TOWN OF CORTLANDT PLANNING BOARD

**MEETING AGENDA.....PLANNING BOARD
TOWN OF CORTLANDT
6:30 TUESDAY EVENING
DECEMBER 5, 2023**

Project: Ace Hardware Store Expansion - Proposed Site Plan Alterations

**Re: Riverview Industrial Park, LLC
260 6th Street
Amended Site Development Plan**

Plan Title
PROPOSED SITE PLAN

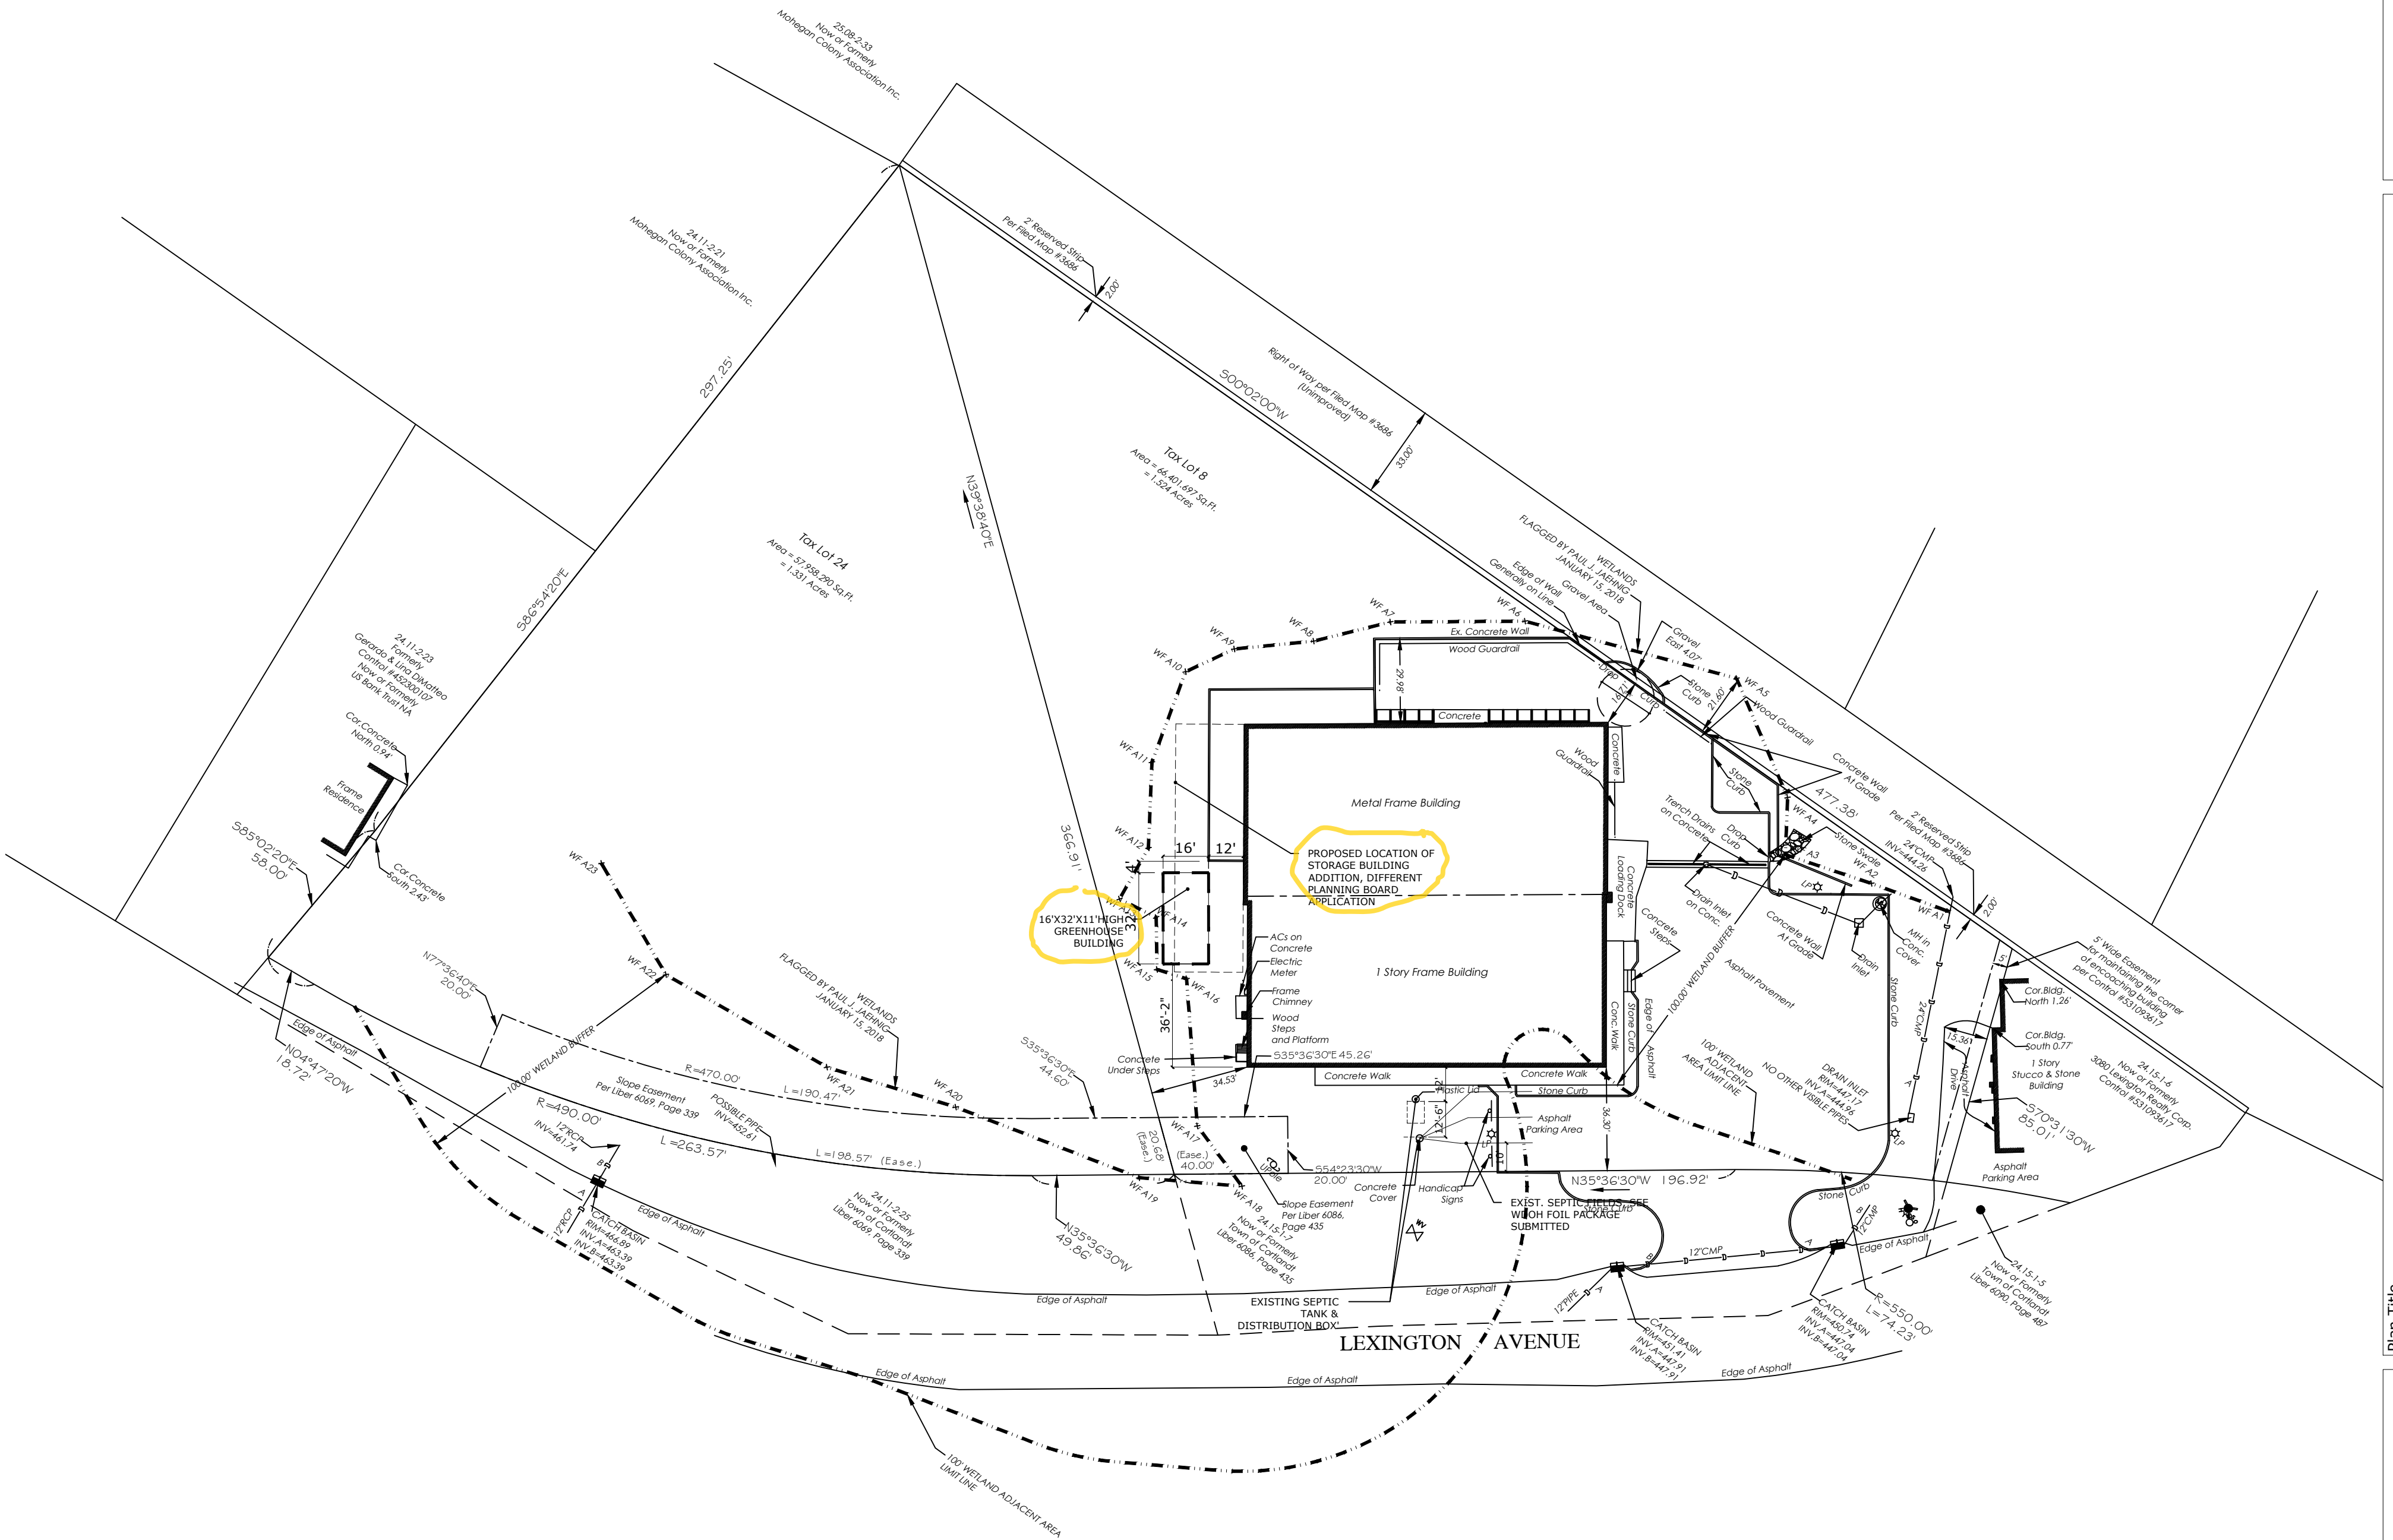
4. The proposed mitigation area of 5,000 sq. ft. appears to be rather generous in terms graphic depiction. When closely looking at the proposed quantity of plantings over this area, the quantity appears to be skimpy.

5. The wetland is a NYSDEC wetland and permit approval from them will be needed. The NYSDEC wetland validation is more than 5 years, and it would be expected the NYSDEC staff will need to have re-validation of the wetland boundary as part of the agency review. The applicant should provide any information from the agency with regards to this.

6. It is recommended that the applicant provide stake-out in the field of any proposed addition so that reviews may have a more informed idea of what may or may not be involved with the proposed addition with regards to impacts to the wetlands and or wetland buffer.

Sherwood Truitt's response: The preliminary mitigation plan can easily be more detailed. Wetland suited plants, bushes or trees can easily be added. By proposing a 5,000 SF mitigation area, we are also proposing to remove invasive species and therefore increasing the positive impact on the existing wetland.

HS-Architecture's Response: Will comply. An application with the NYSDEC has been filed already. We are currently waiting for a response to our revised application.

HS-Architecture's Response: Will comply. The land surveyor can stake out the proposed addition and we can establish an onsite meeting to walk the site and further discuss the overall means and methods during construction.
